STAFF REPORT
(ONE-STEP FINAL PLAT)

CASE NUMBER: SUB 2002-72 --SOUTH LAKES COMMERCIAL ADDITION

Re: Drainage Plan
South Lakes Commercial Addition

VICINITY MAP

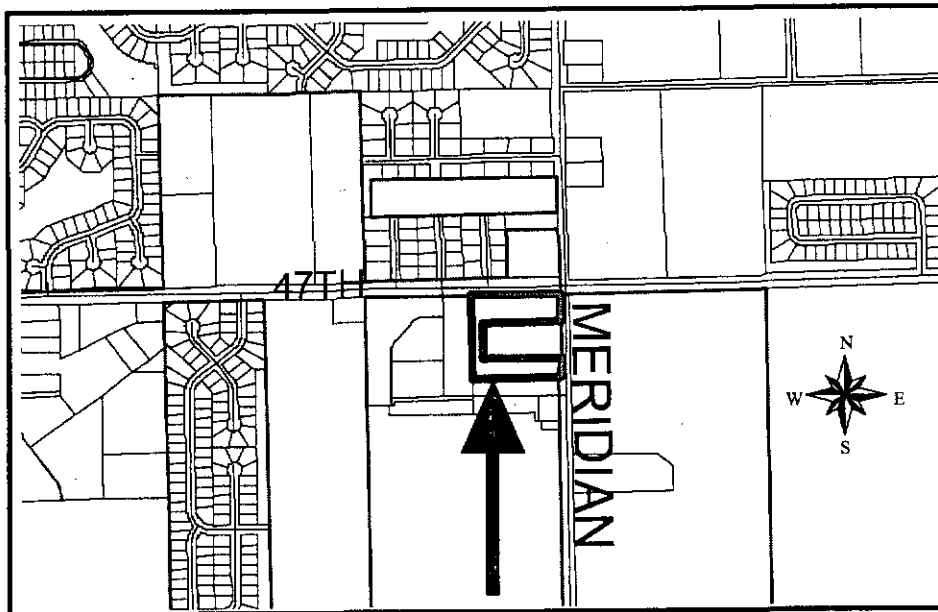
*Drainage plan needs
to be revised
need to ext. sewer*
